**HARTZELL PROPELLER INC.**  
**SERVICE BULLETIN**  
**TRANSMITTAL SHEET**  
**HC-SB-61-372**  
**Governor - Speeder Compression Spring**

December 01, 2016

This page transmits a revision to Service Bulletin HC-SB-61-372.

Revision 1 is issued to change the following in this Service Bulletin:

Spring Identification  
Figure 1

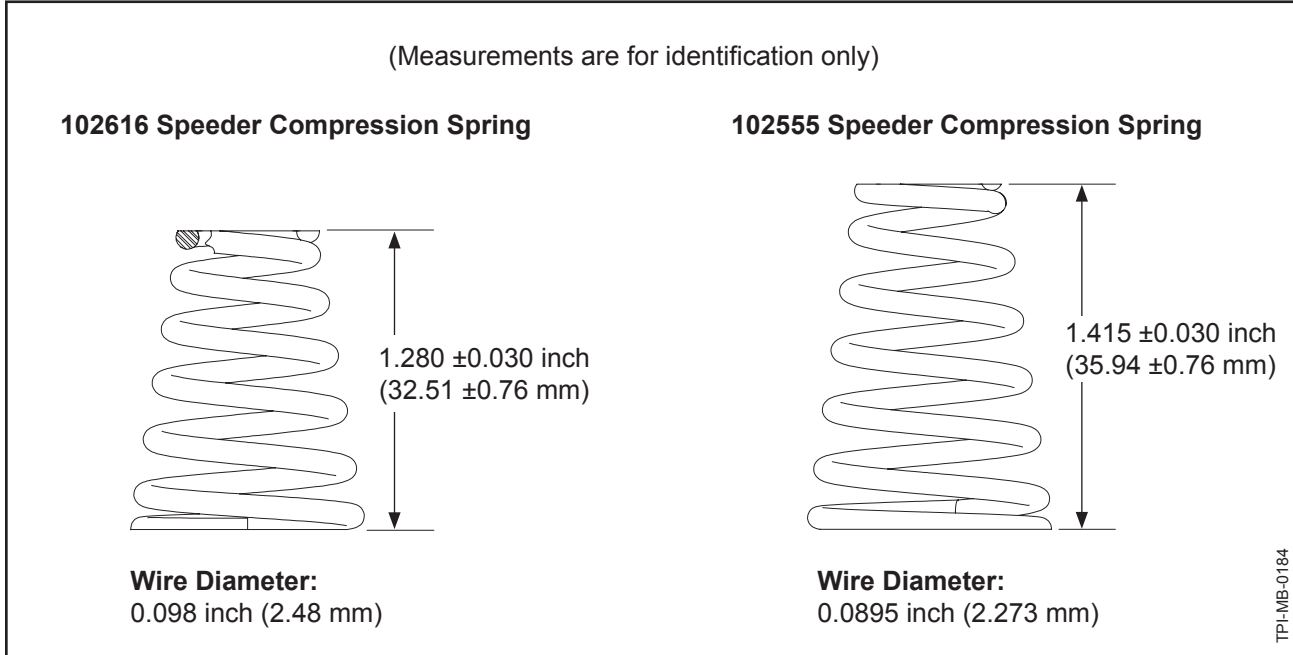
- (1) This Service Bulletin provides Instructions for Continued Airworthiness (ICA).
- (2) This Service Bulletin introduces the 102616 speeder compression spring as a replacement for the 102555 speeder compression spring used on the affected governors. Refer to Figure 1 for spring identification.

- (1) At next governor overhaul, install a new or serviceable 102616 speeder compression spring and a new or serviceable 102368 control lever in accordance with the Accomplishment Instructions in this Service Bulletin.

Control Lever Identification  
Figure 2

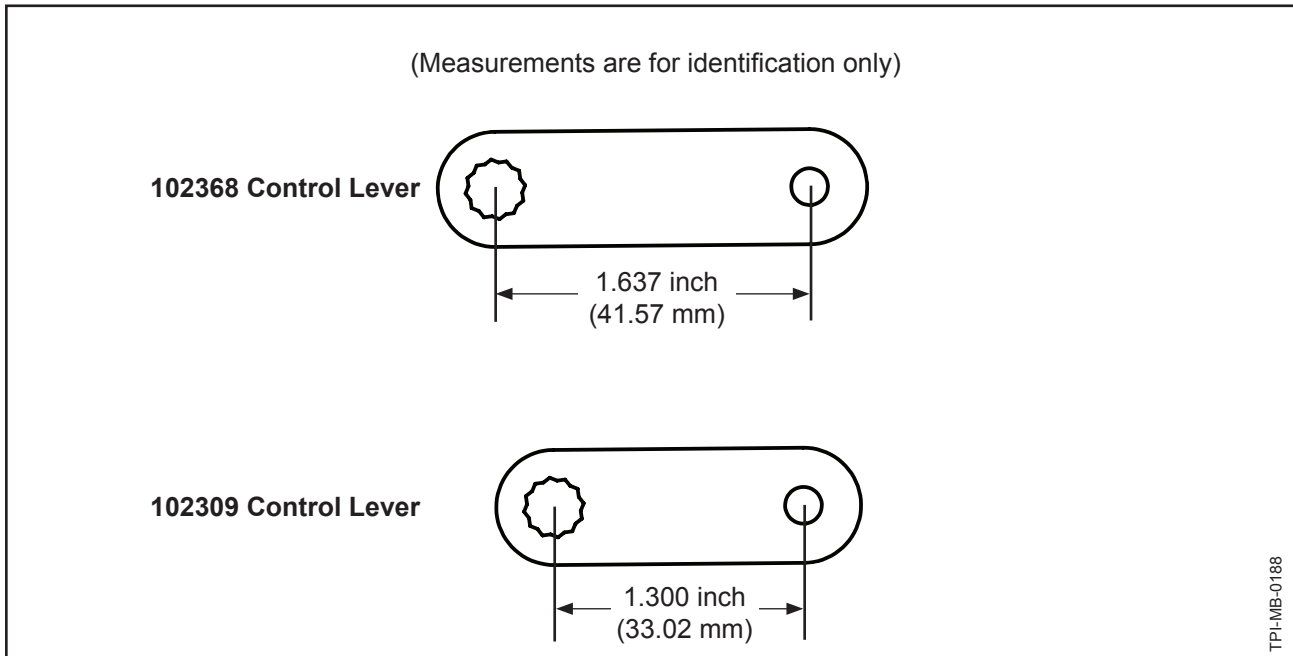
- (3) This Service Bulletin introduces the 102368 control lever as a replacement for the 102309 control lever used on the affected governors. Refer to Figure 2 for control lever identification.
